<b>Project</b>	Steamboat Base Village Redevelopment	<b>Date</b>	07/30/2021
<b>Project Location</b>	Steamboat, Colorado	<b>Architect's Project Number</b>	03.7835.000
<b>Owner/Client</b>	Alterra Mountain Company / East West Partners	<b>File</b>	6BL <b>This is page</b> 1 of 3
<b>To</b>	Saunders Construction Inc.	<b>Attention</b>	Bryan Sculthorpe
<b>Address</b>	86 Inverness Place North		
<b>City</b>	Englewood	<b>State</b>	CO <b>Zip Code</b> 80112
<b>Delivered via:</b>	<input type="checkbox"/> Messenger	<input type="checkbox"/> Hand carried	<input type="checkbox"/> Facsimile
	<input type="checkbox"/> Express	<input type="checkbox"/> Pick-up	<input type="checkbox"/> E-mail Address
	<input type="checkbox"/> Mail	<input type="checkbox"/> UPS	<input checked="" type="checkbox"/> Website Address BIM360

**Attachments** BP3 PROMENADE - BULLETIN 06

## Description of Changes

- Updated steel for plaza building revisions
- Updated plaza building footprint and shaft opens
- Added slab step plan
- Updated underground MEP to match Bulletin 06

DESCRIPTION  
 PERFORMANCE SPECIFIED FRAMING

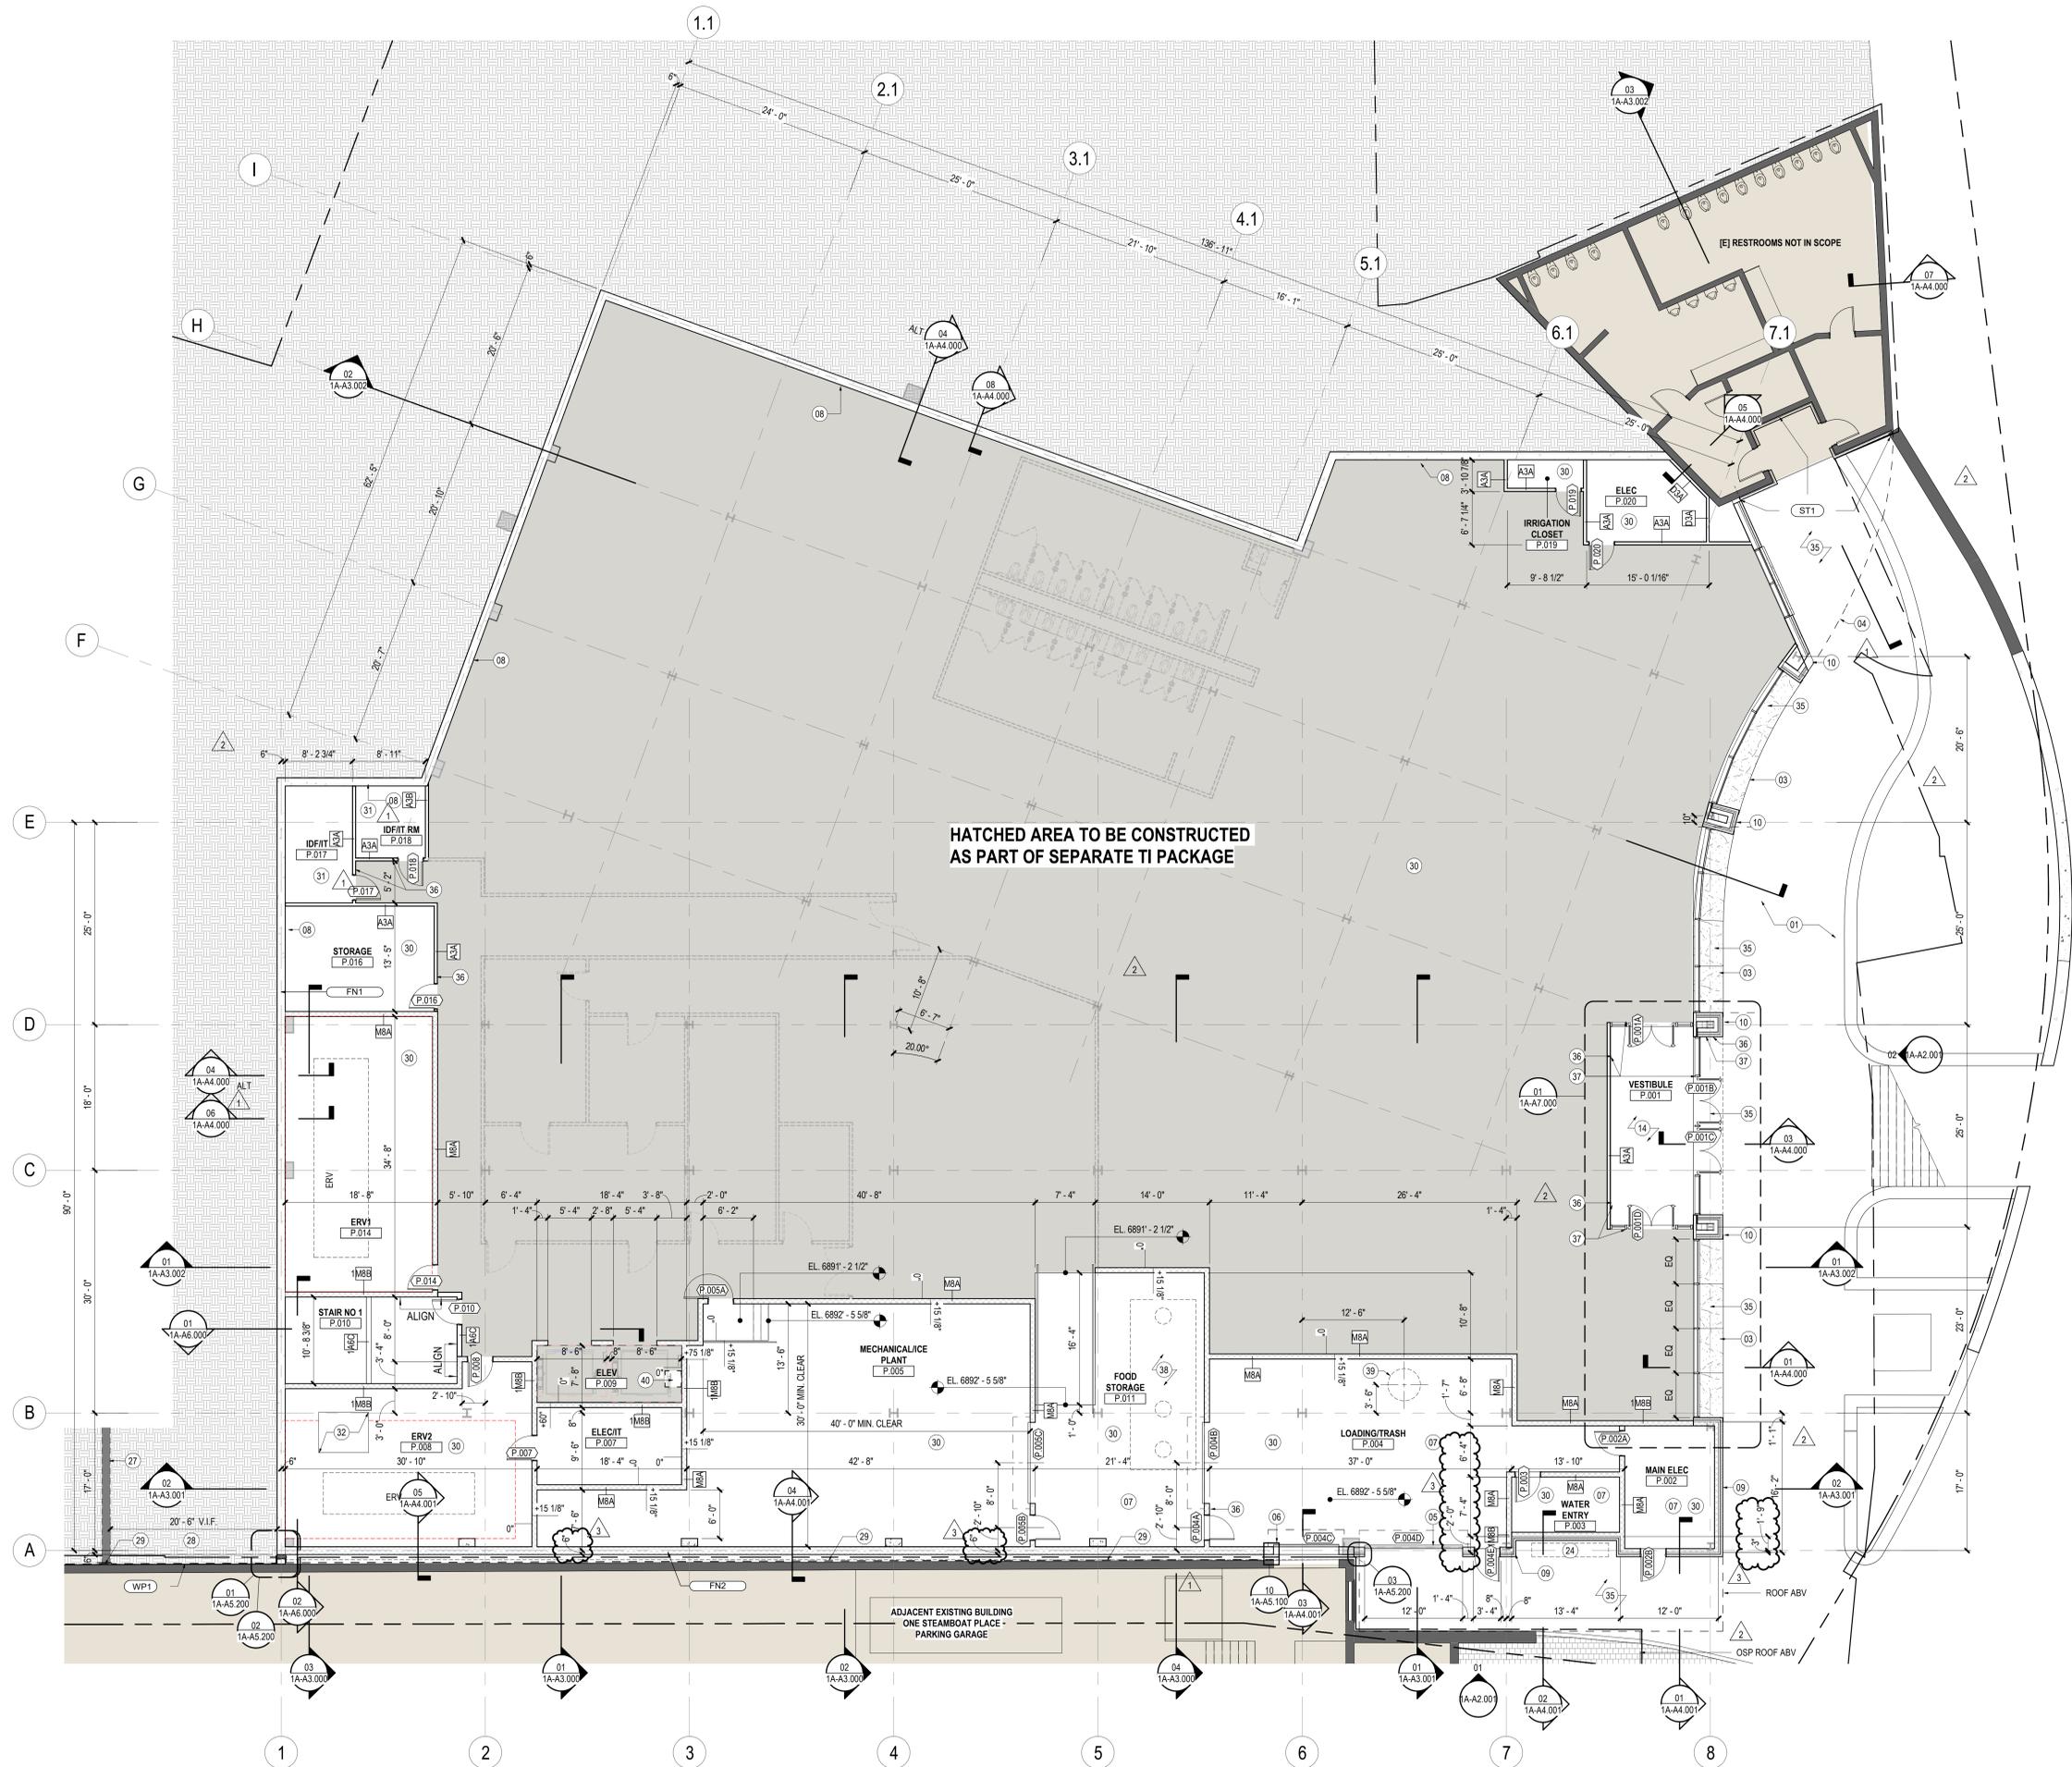
- a. Detail 5: Top of pit wall and top of pit slab elevations are added.
- b. Detail 9: Detail added.
- c. Detail 10: Detail added.
- 10. 1A-S5.30:
  - a. Detail 5: Cold formed and stone angle is revised per RFI039.
  - b. Detail 10: Detail removed.
  - c. Detail 11: Top of slab updated.
  - d. Detail 13: Detail added.
  - e. Detail 14: Detail added.
- 11. 1A-S5.40
  - a. Detail 13: Stone angle is updated per RFI039.

**1A-A1.201**

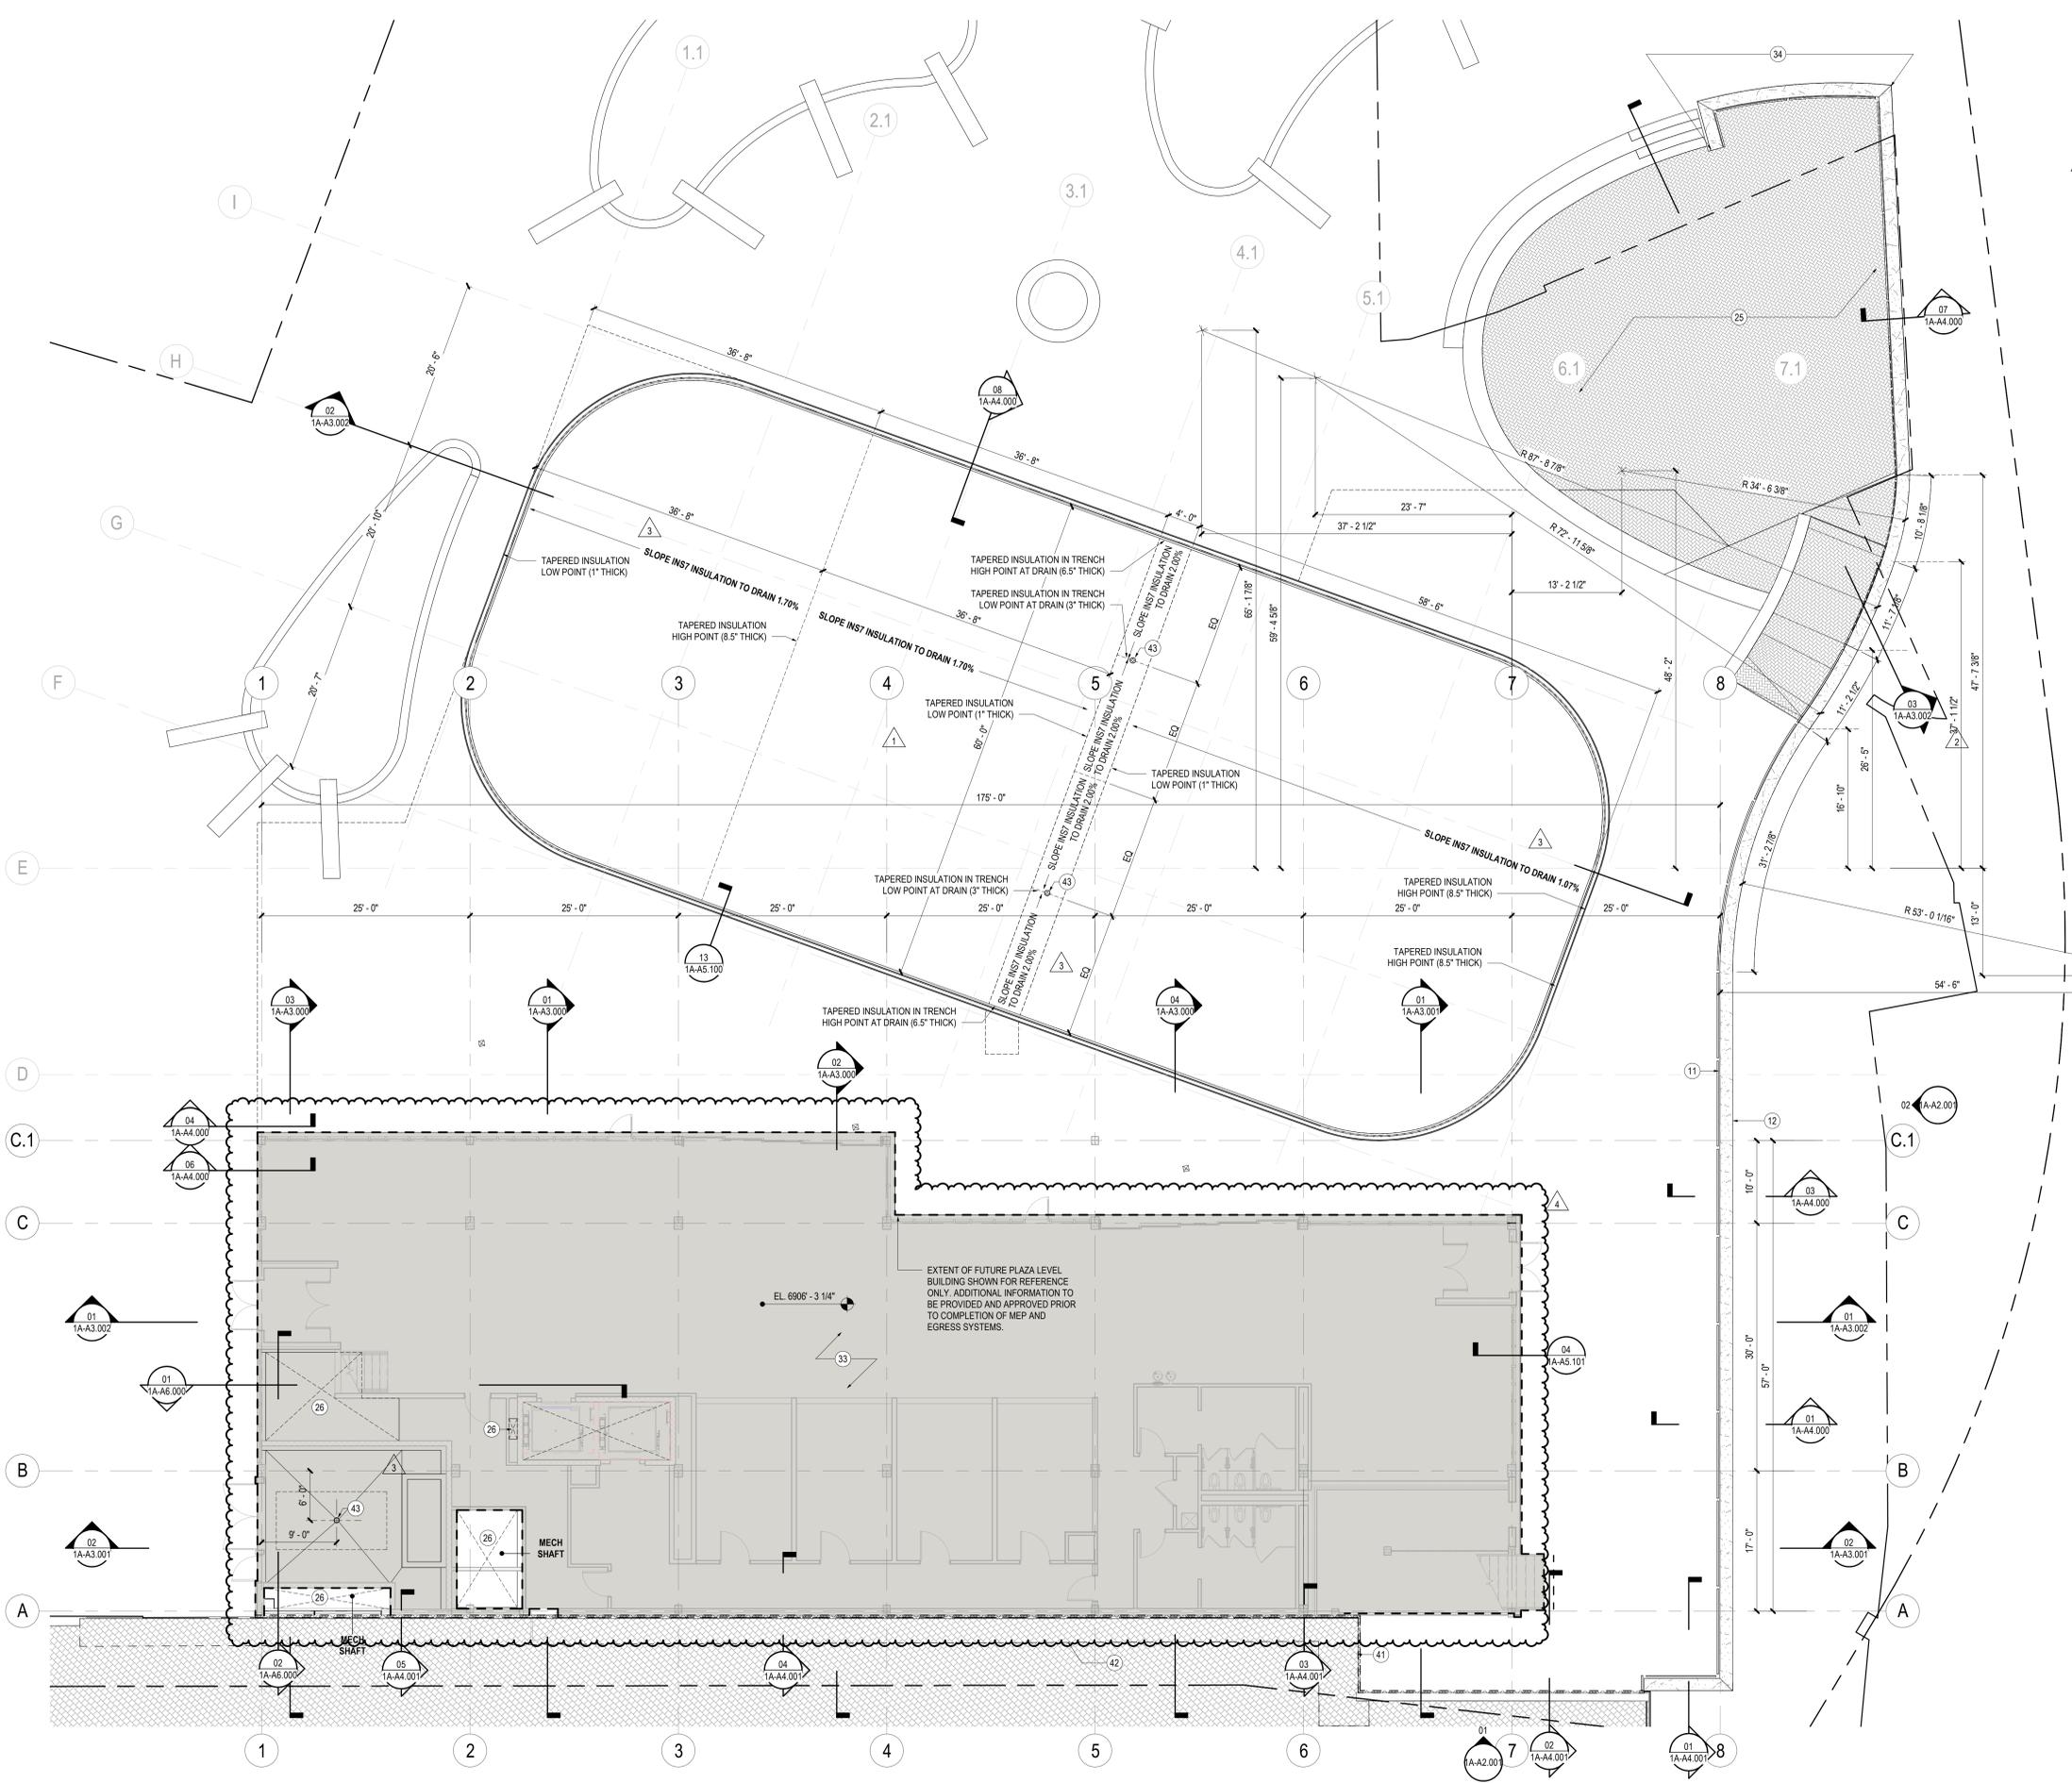
- 1. 1A-A1.200
  - a. Added clarifying dimensions
- 2. 1A-A1.201
  - a. Revised shaft openings and plaza building footprint
  - b. Added floor drain to Zamboni garage
  - c. Removed dimensions on slab plan (see 1A-A1.201S)
- 3. 1A-A1.201S
  - a. Added dimensioned slab step plan
